Zoning & Planning Committee Agenda

#38-22 Request for discussion and amendments to the Zoning Ordinance and Zoning Map regarding village center districts

Comments and possible amendments for VCOD
Susan. Albright

To: Members of the Zoning and Planning Committee
From: Councilor Lisle Baker
Date: July 28, 2023
Subject: Zoning amendments for consideration on Monday the 31st.

Newton Highlands / Eliot T / Rt. 9

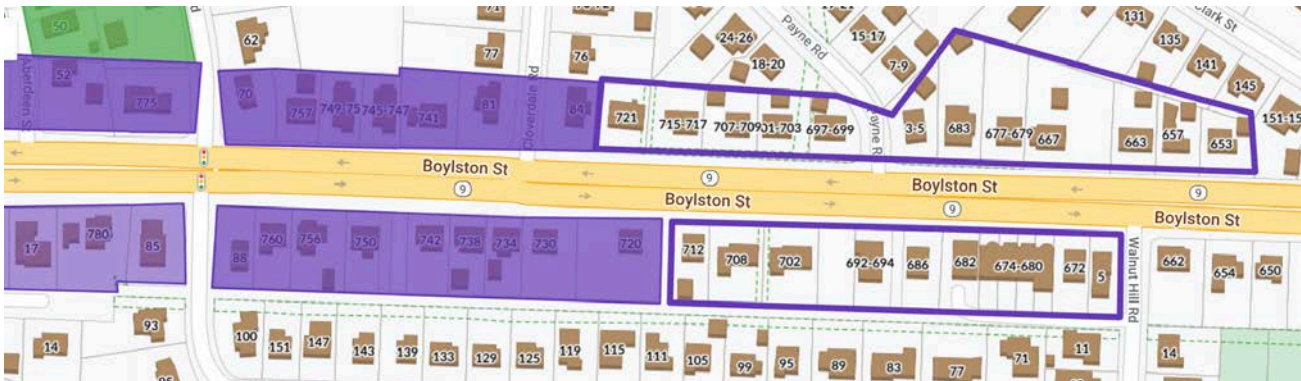
- Additional MRT to connect Newton Highlands to Eliot.
- There are many large Victorians on both Lincoln and Erie.
- Right next to Eliot are three lots owned by the same person. That's why the MRT goes up Harrison.

- Additional MRT down Walnut and Lake Ave. as they are so close to the T. There is an entrance to the T on Hyde St. so these lots are very close to transit.

- The section of VC1 that is not filled in with purple is hardly a walkable area.

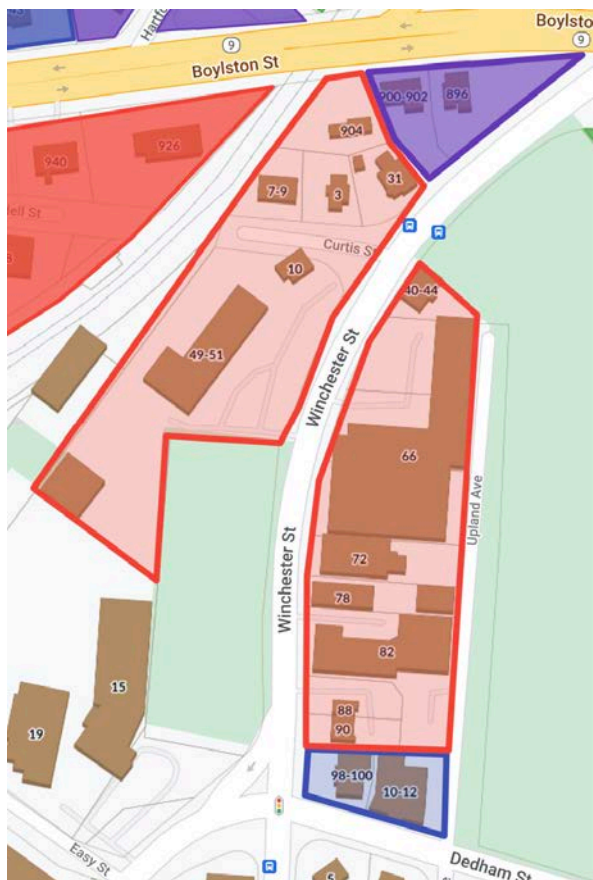
- An area that could have more VC3. Especially on the west side of Winchester St. – large underused lot with a 2 story building. About 1/3 mile from T.
- The VC3 extends to Rt. 9 because that lot has same owner as one on Winchester St. Could access from there.

Auburndale

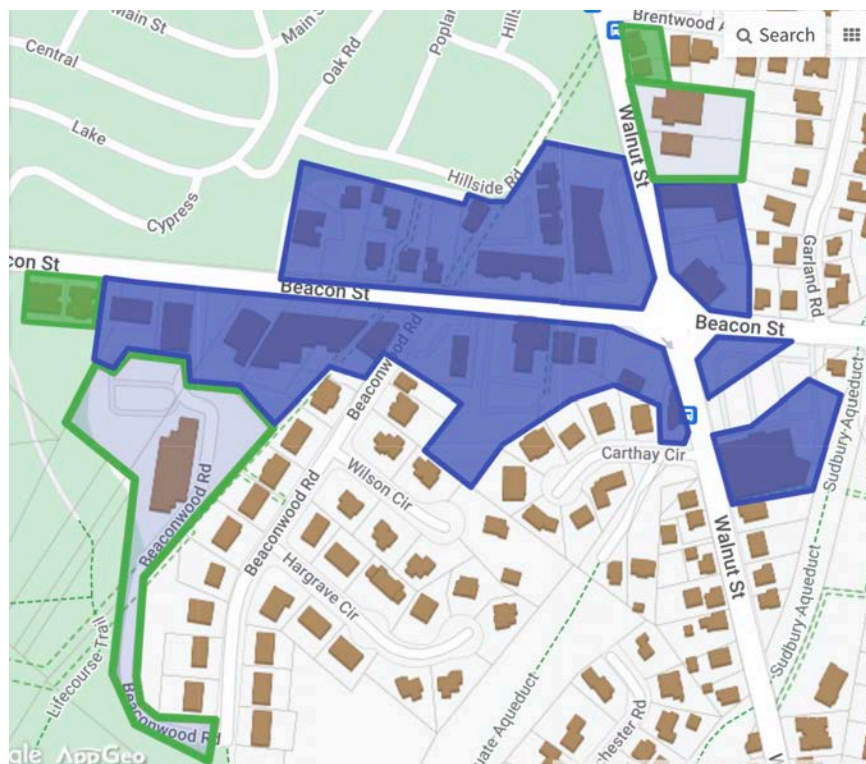
- The area for more VC2 on the left side of this map currently has Newton Housing Authority buildings. In future may want to do more.
- Star market and parking area could have more height, especially near the Pike

West Newton

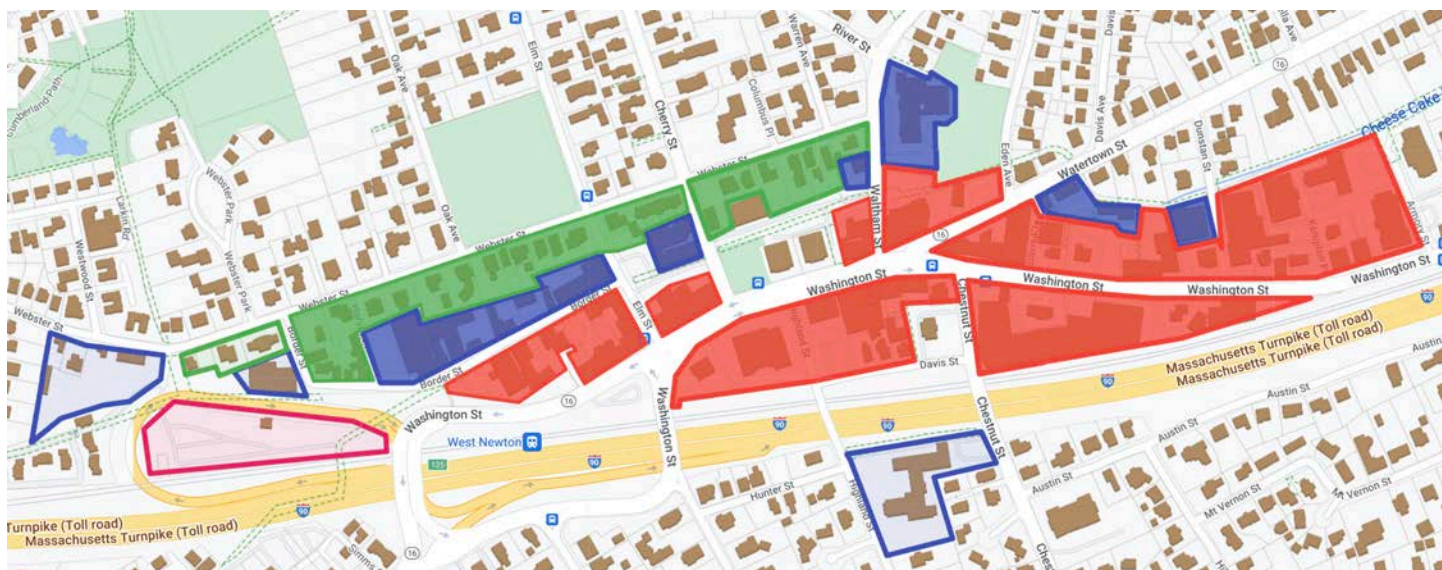
- The MBTA parking lot in Waban is zoned so the MBTA parking lot in West Newton could also be zoned.
- A lot of underutilized land on the left side of this map.

- The VC2 on the other side of the Pike is Second Church. They wrote a letter asking why they were not being rezoned since FUSN was. They have a large lot and large buildings now. There had been a school in one of their buildings that is no longer there. I could see how they might want to build housing on their lot.

Newton Corner

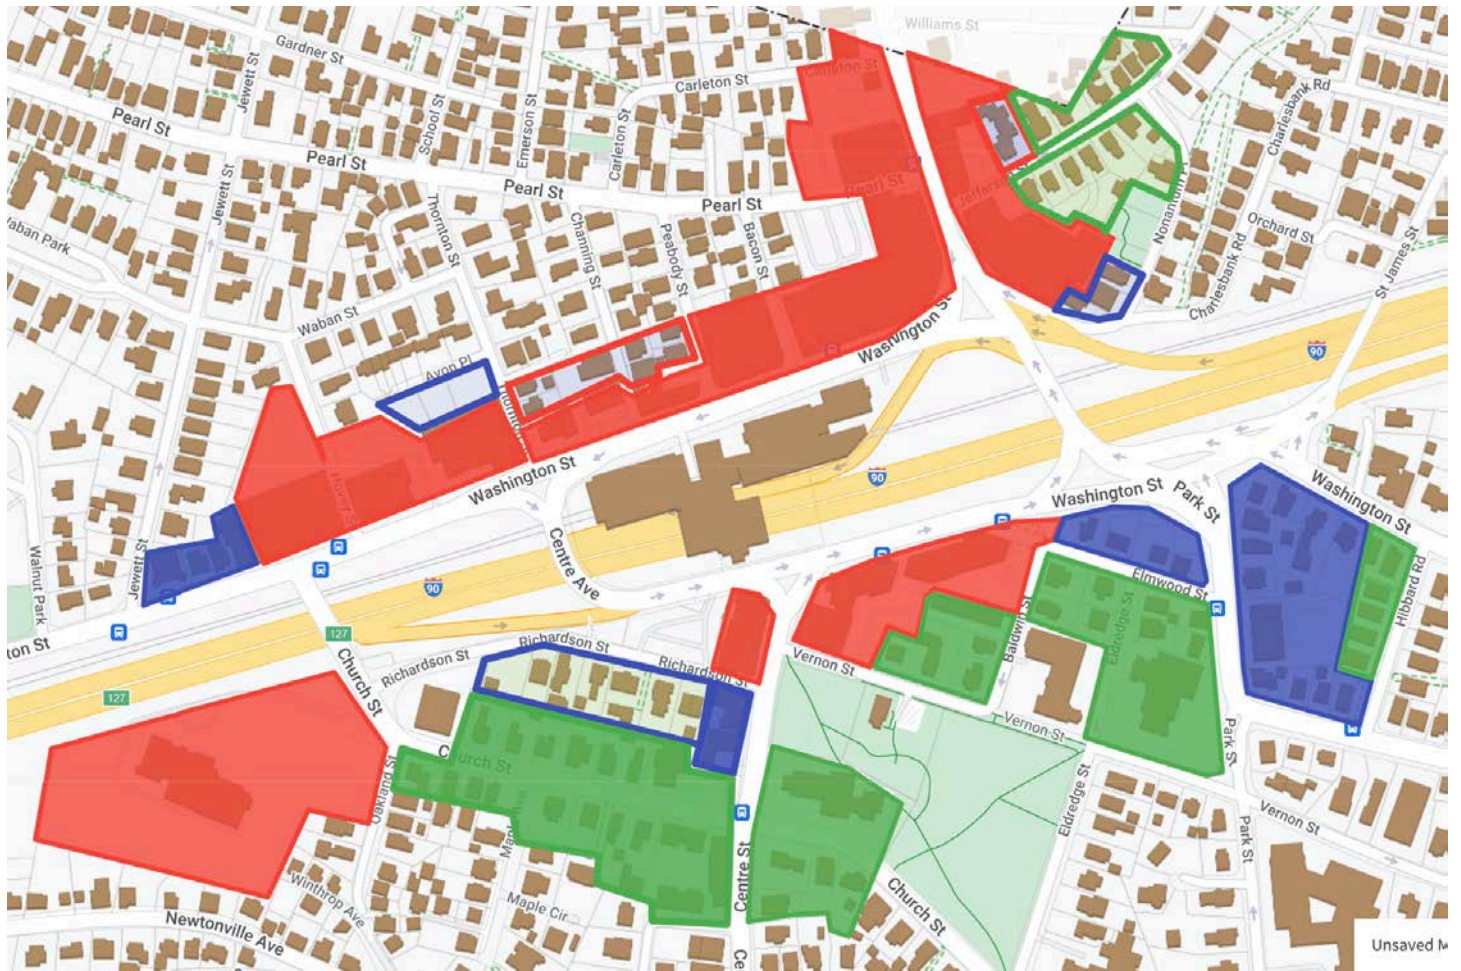
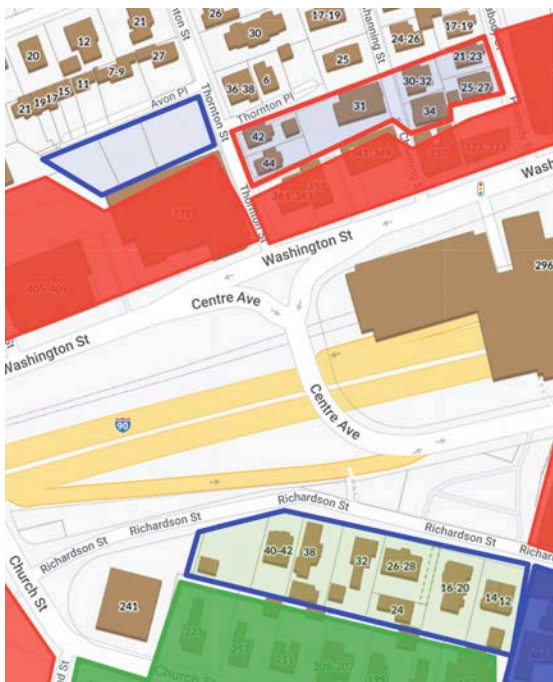
- Some of the lots north of the Pike could be VC2 instead of VC3 to transition to the neighborhood

Newton Centre

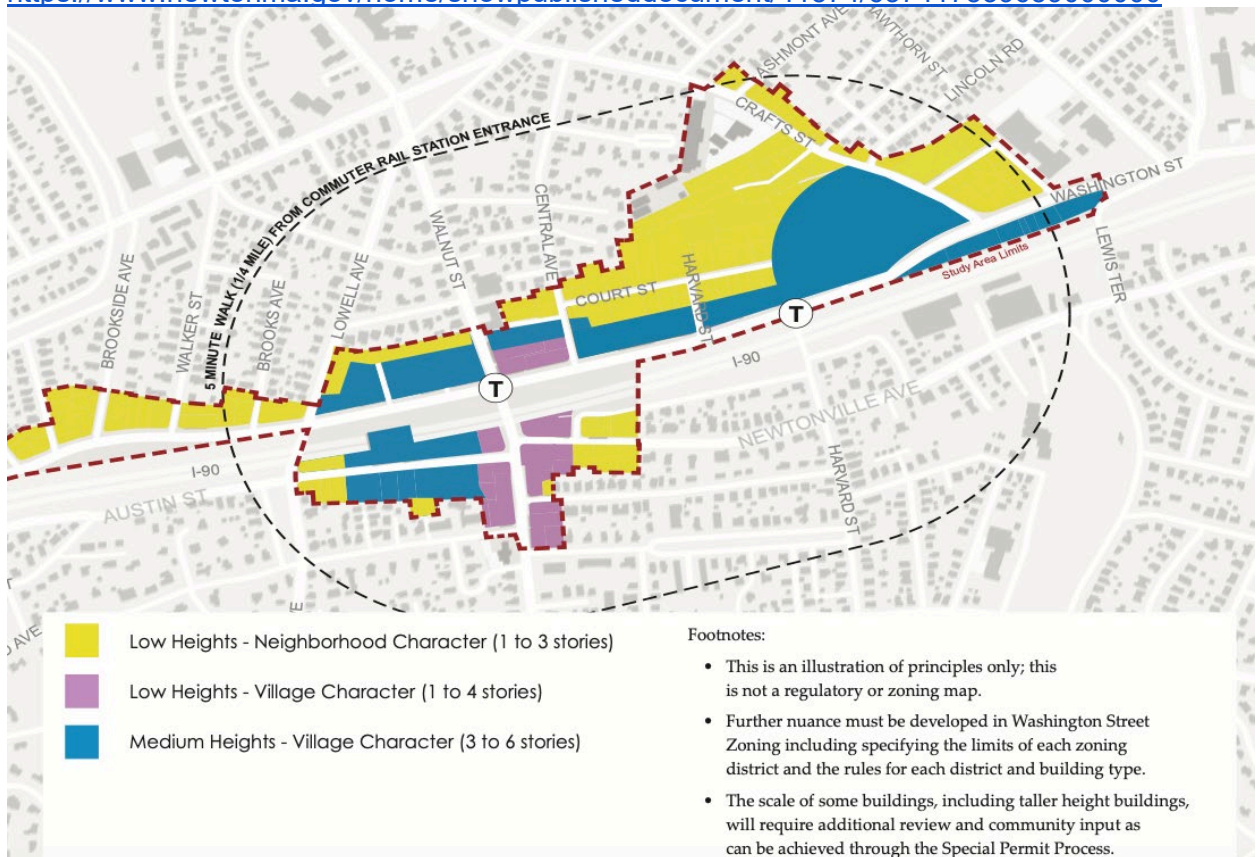
- The areas that could be VC2 instead of MRT currently have 3 story buildings on the lot. MRT would be downzoning those lots.
- On Beacon St., the second lot in from the corner of Centre and Beacon currently has a 1 story commercial building. Should be VC2 or VC3 instead of MRT.

Proposed Changes in Newton Center south of T

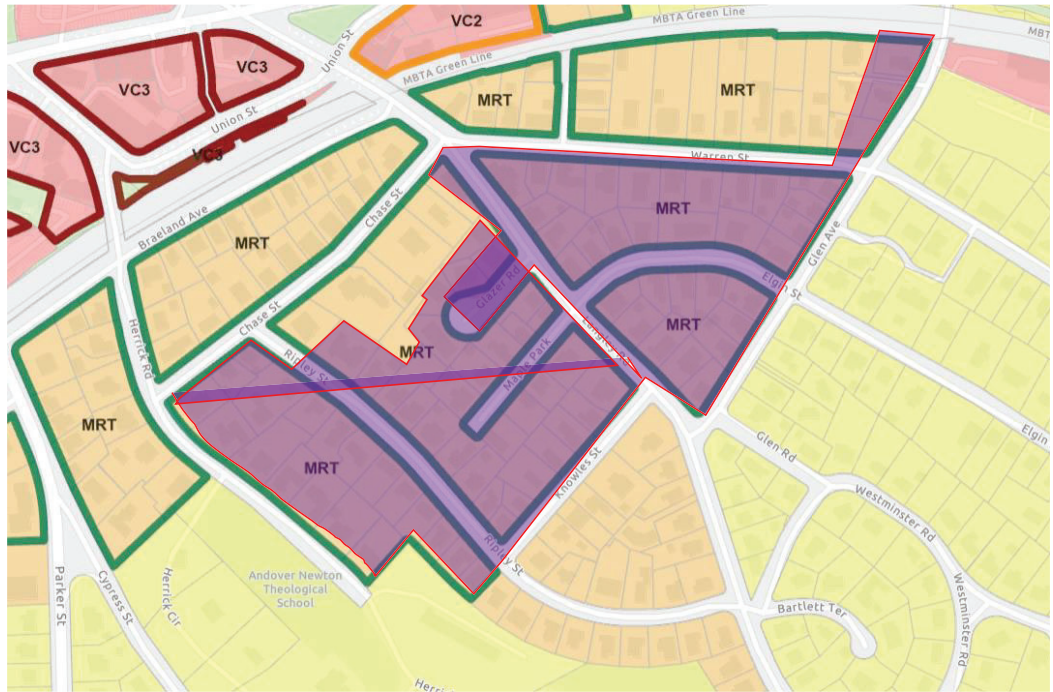
Remove these properties from MRT

Proposed Changes in Newton Center north of T

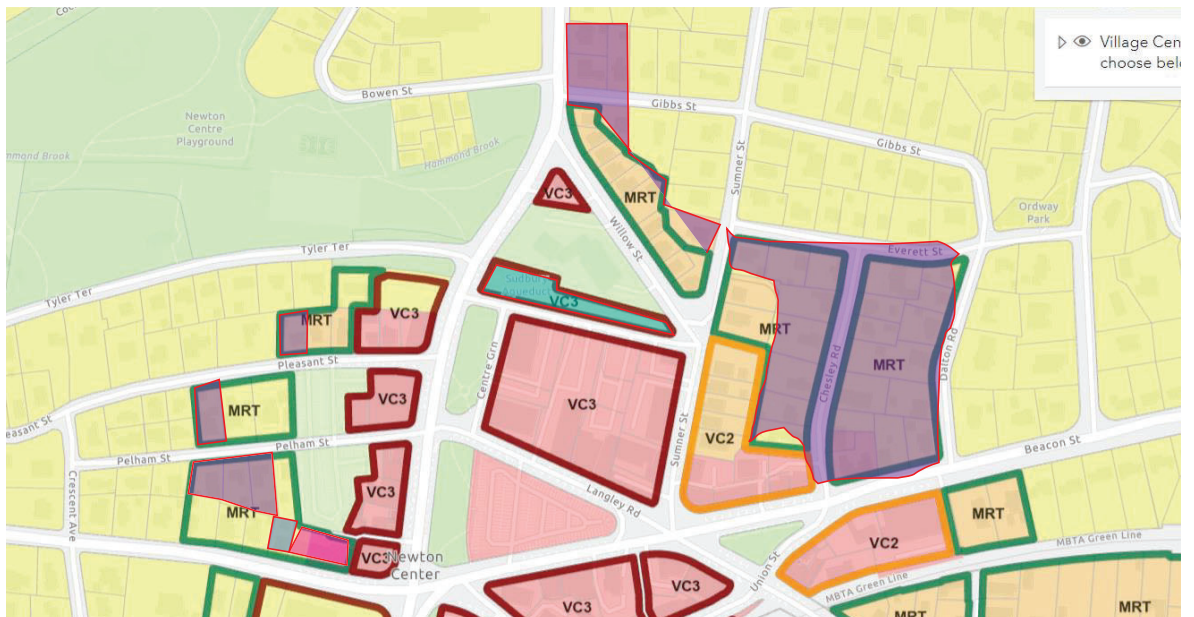
Remove these properties from MRT

Add these properties to MRT

Change these properties from MRT to VC2 or VC3

Change these properties from MRT to VC1

Remove this property from VC3

Proposed Changes in Newton Center west of T

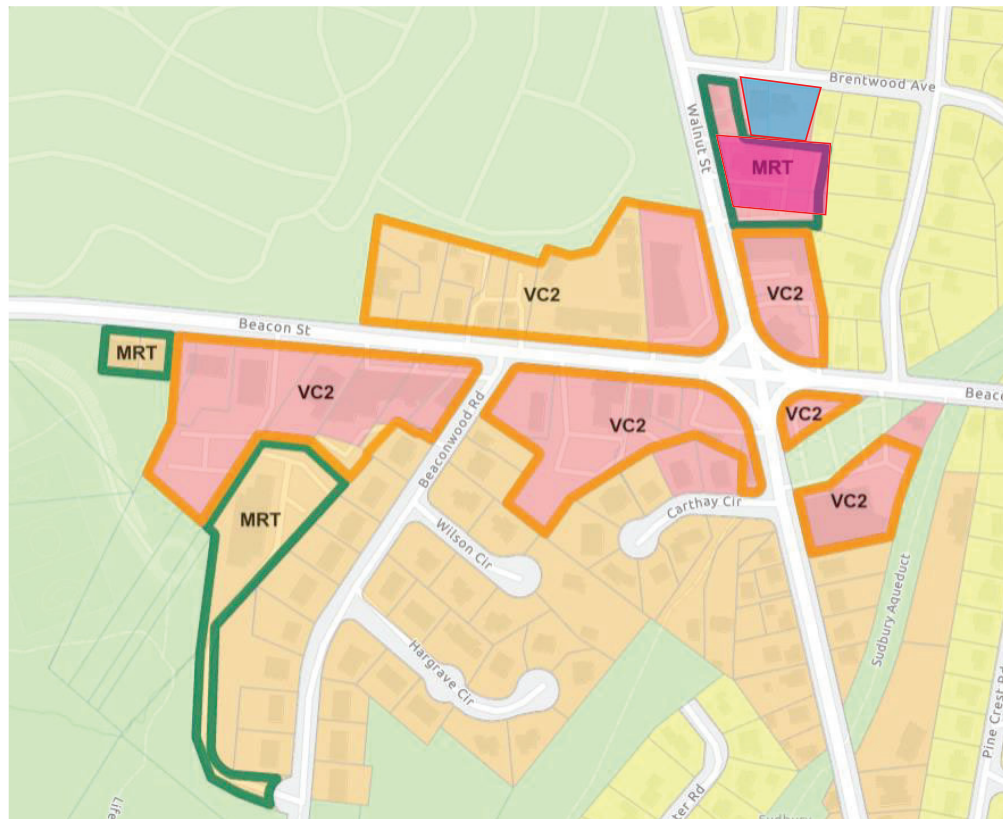
-  Remove these properties from MRT
-  Add these properties to MRT
-  Change these properties from MRT to VC2

Proposed Changes in Four Corners

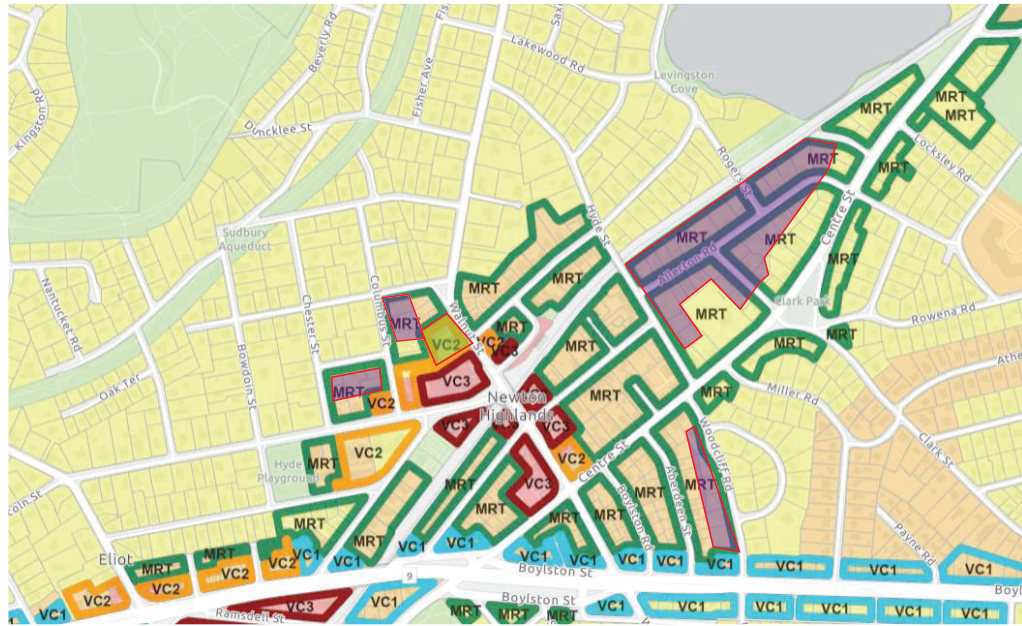
-  Add these properties to MRT
-  Add these properties to VC2
